RE: S/D 98-101 -- One-Step Final Plat of U-NEEDA SELF STORAGE ADDITION

RE: S/D 98-101 -- One-Step Final Plat of U-NEEDA SELF STORAGE ADDITION

CASE NUMBER: S/D 98-101 - U-NEEDA SELF STORAGE ADDITION

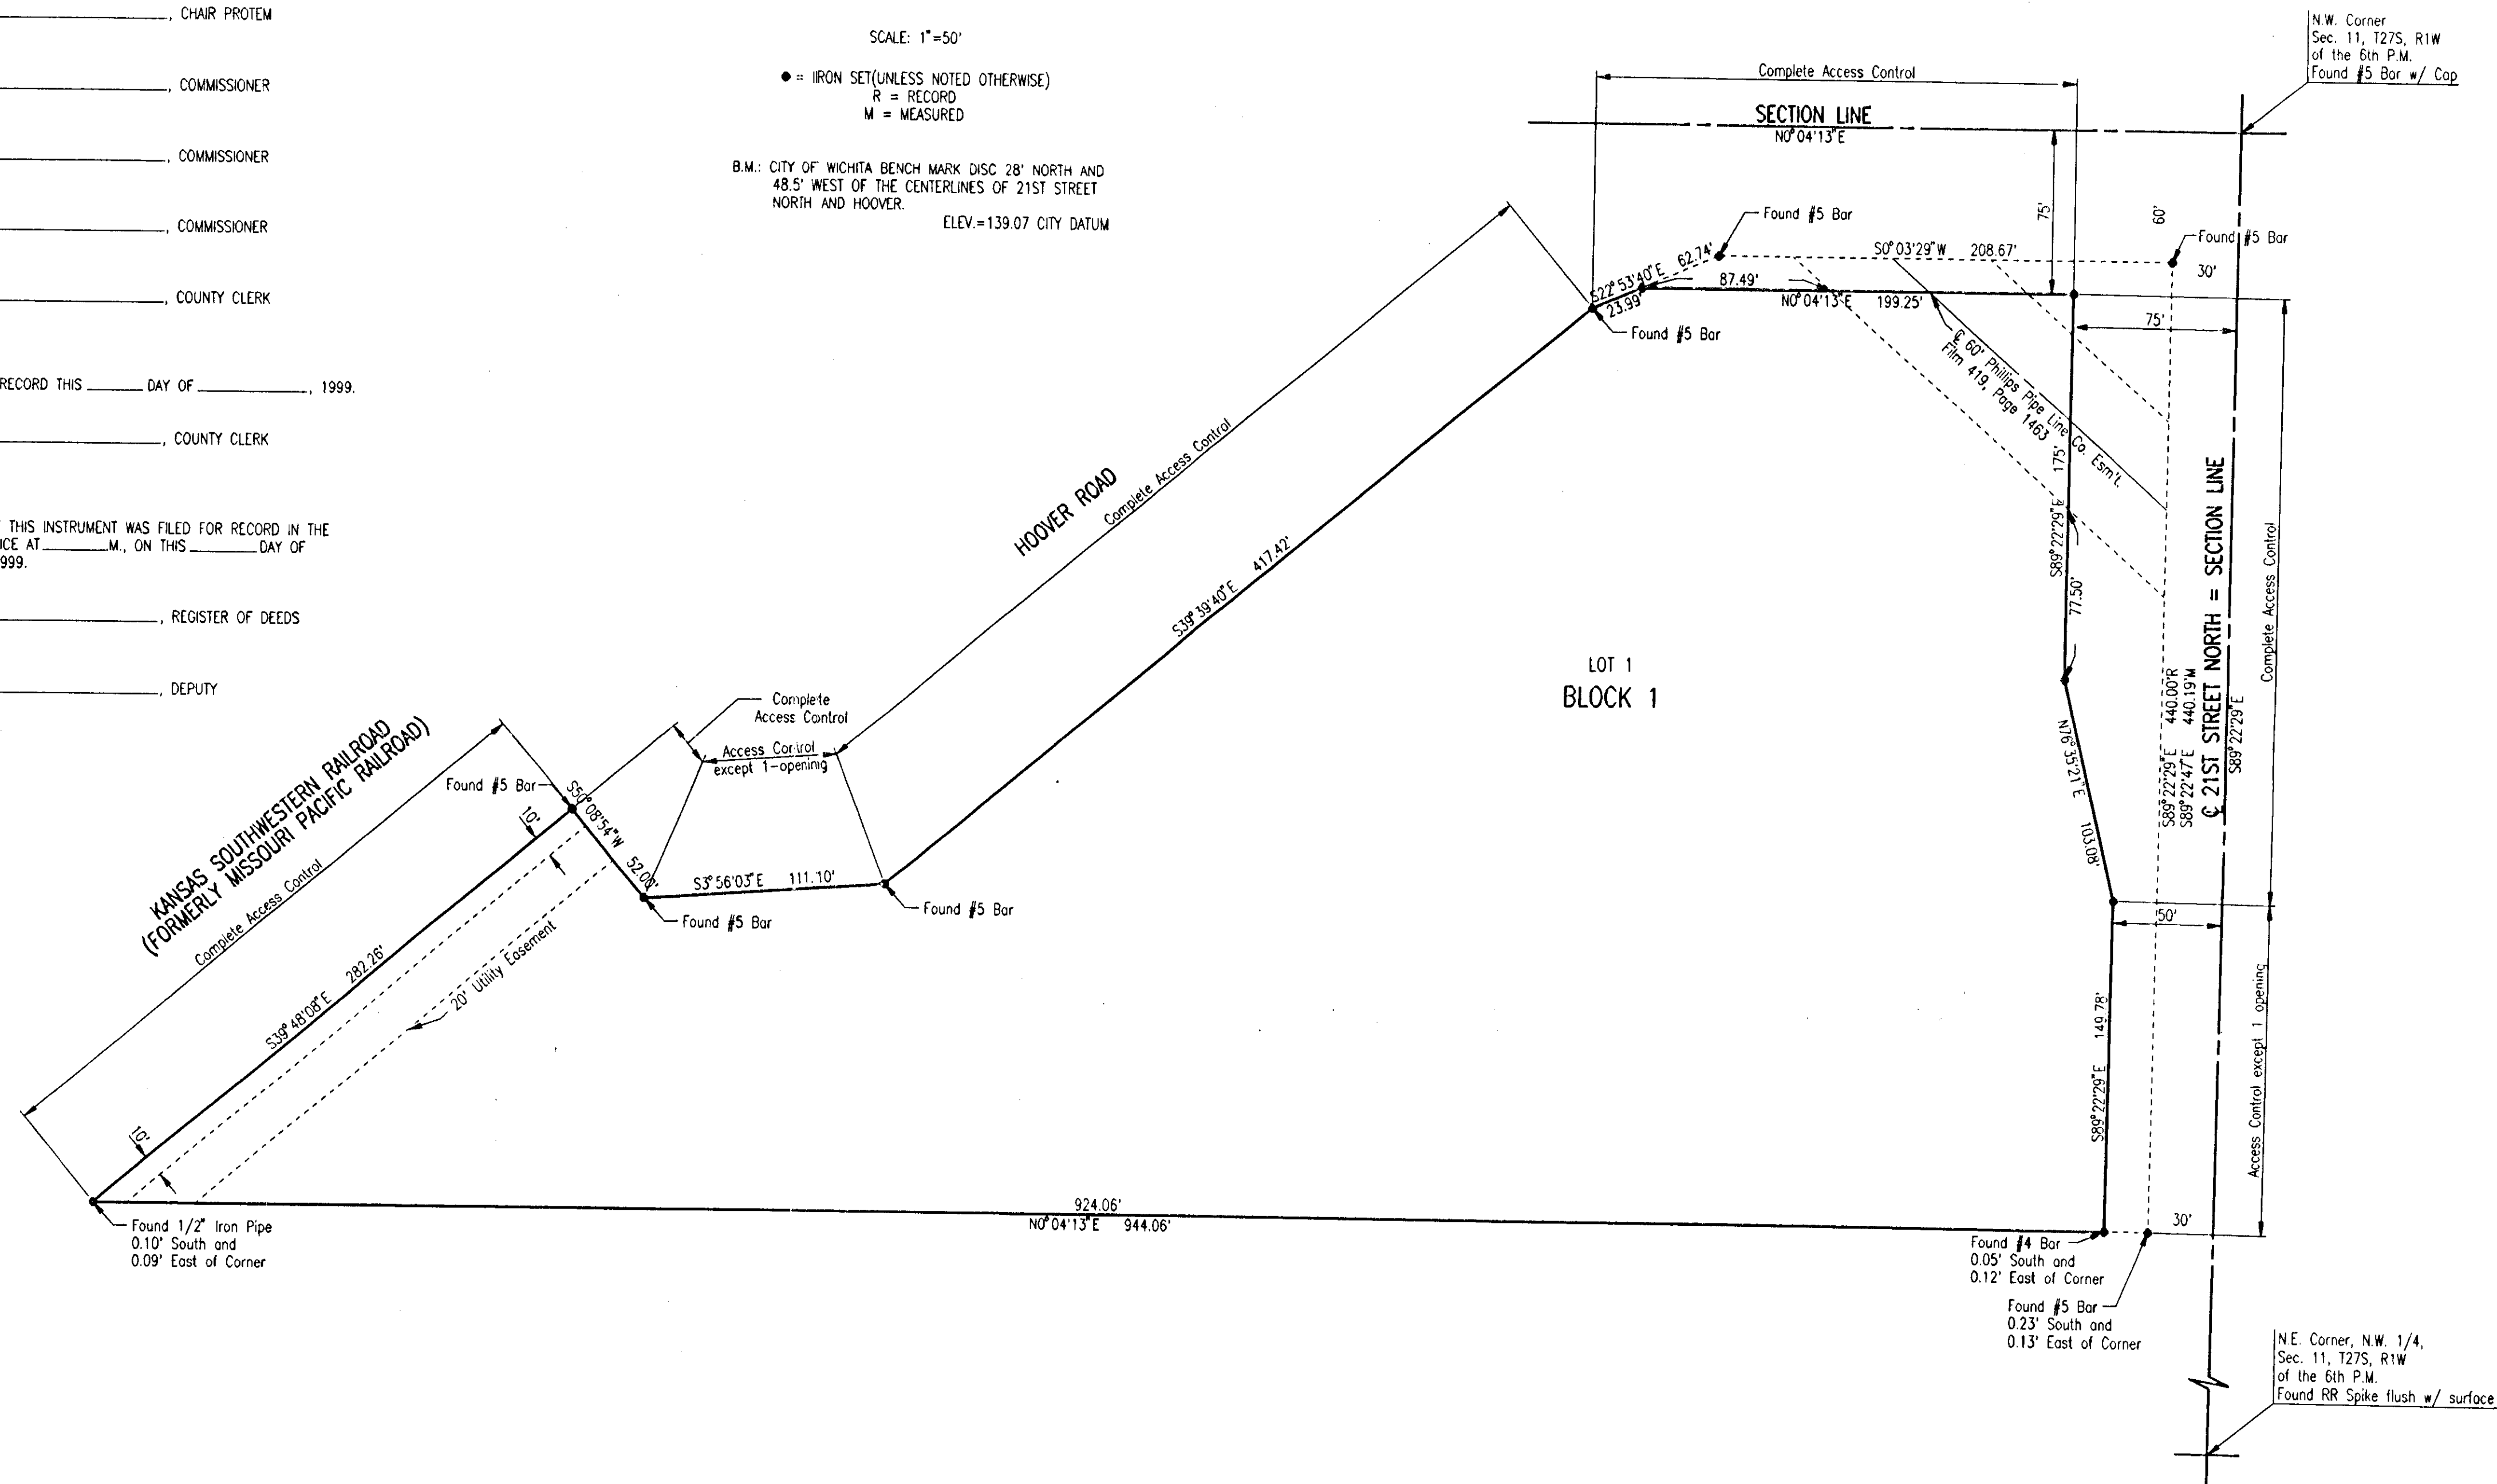
- F. The zone change was approved subject to conformance with a site plan which denoted one access opening along Hoover on the southern portion of the plat and one opening along 21st St. North. The plat is not in conformance with the site plan, as it denotes two openings along Hoover. Distances should be shown for all segments of access control. **Traffic Engineering and MAPD require one opening along Hoover. County Engineering requires complete access control be obtained along the railroad right-of-way.**

- G. The plat's text should reference the dedication of right-of-way for Hoover and 21st St. North.
- H. In addition to the pipeline easement platted on this site, the platting binder indicates there is another pipeline easement located on the property. The Applicant shall either obtain a release of the easement or denote its location on the final plat tracing.
